S E R V I C E N O T E

6553A 500W General Purpose Power Supply

Bridge Rectifier Failure

Page 2 Service Note 6553A-04

Figure 2a. Diode Assembly

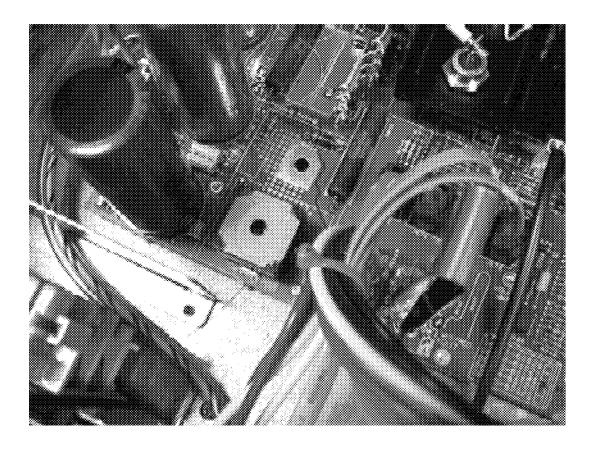
3. With a pair of wire cutters, snip the leads of the bridge on the main board. (See Figure 2a and 2b.) It is not necessary to remove the remaining leads from the board. Please inspect the board to check for any shorts.

To remedy this situation, a diode heat sink assembly will replace the diode bridge that continues to fail. The procedure for replacing these units can be found in the paragraphs below.

Figure 2b. Standoff

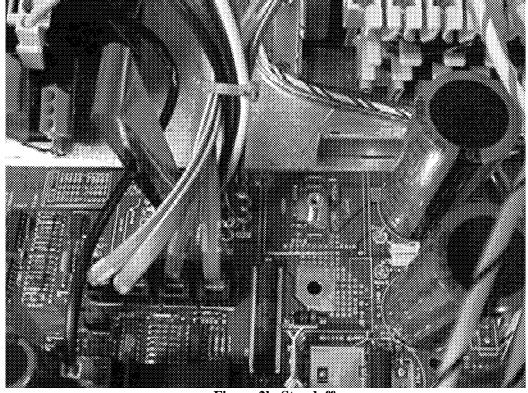
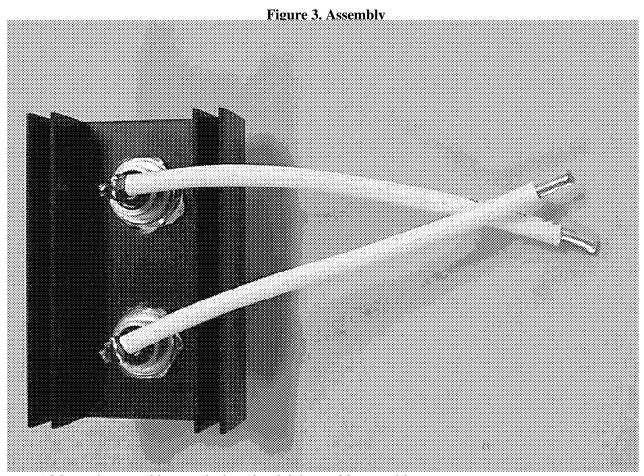
4. Turn the board over to remove the standoff located under the bridge rectifier. Crimp standoff towards middle for easy removal. This will decrease damage to the inner plating of the standoff hole.
